BULLETIN # 03

PROJECT: Harrison Recreation & Community Center – PHASE 1
Harrison, NY

RE: Revised foundation Insulation- Reference RFI-14

1 TYPICAL FOUNDATION SECTION DETAIL
1 1/2" = 1'-0"

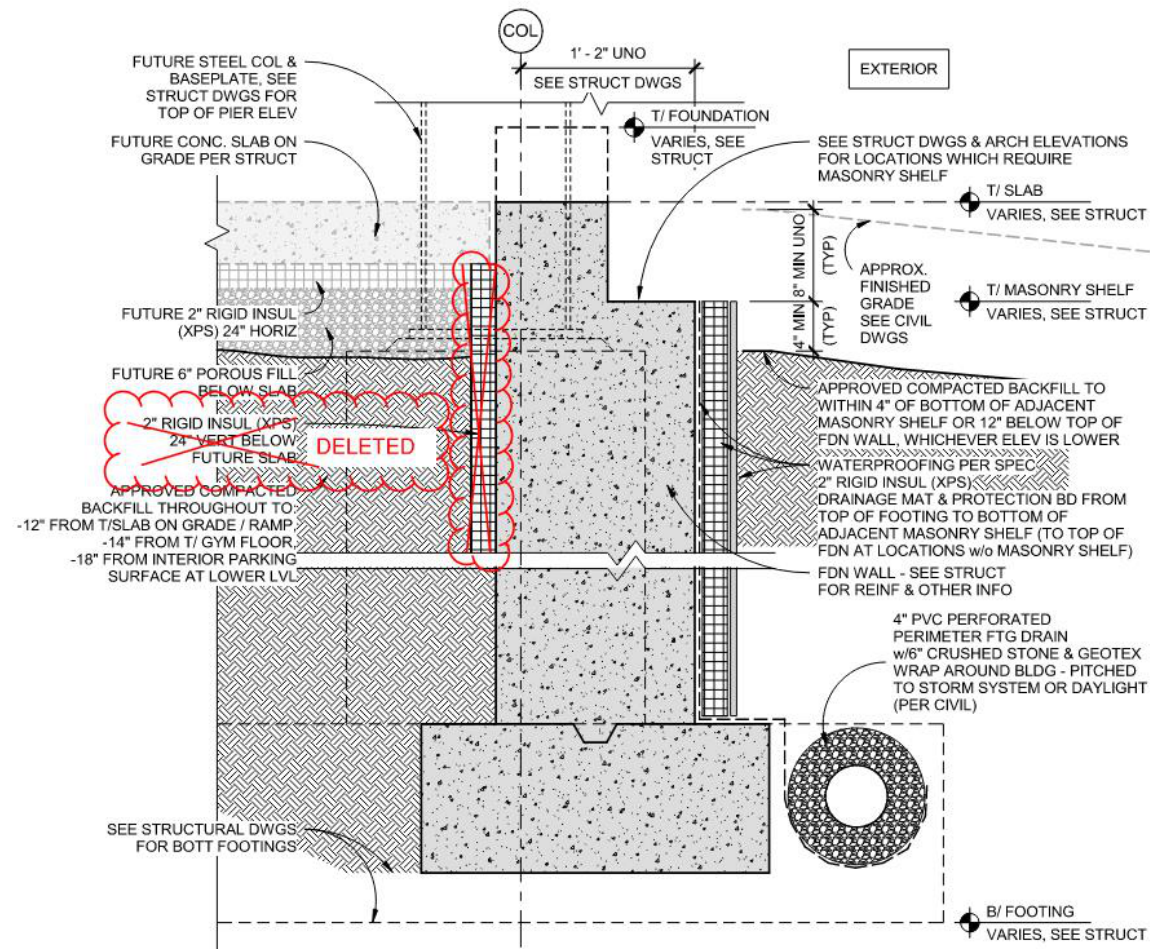
Per the attached ASK-03 delete the 2” rigid insulation located on the interior side of the foundation wall. Please provide a PCO for the deleted material.
